INDESIT company

Model type:
LSF723EU/HA

Commercial code:
F068027

n4513g02: INTRODUCTION OF NEW SYNCHRONOUS MOTOR

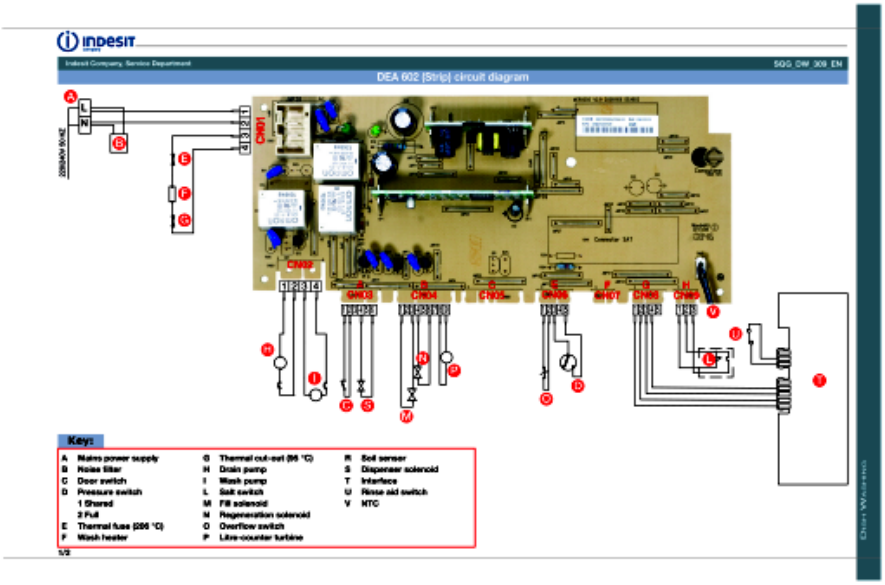
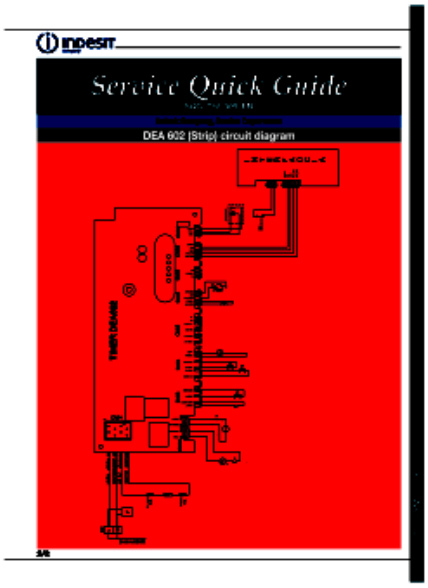
A new electropump has been introduced in the synchronous motor. This is perfectly interchangeable with the previous one, only the dowel has been modified improving its quality.

New motors have new codes:

Old New
C00256523 -> C00302800
C00256525 -> C00302798
C00272798 -> C00302796
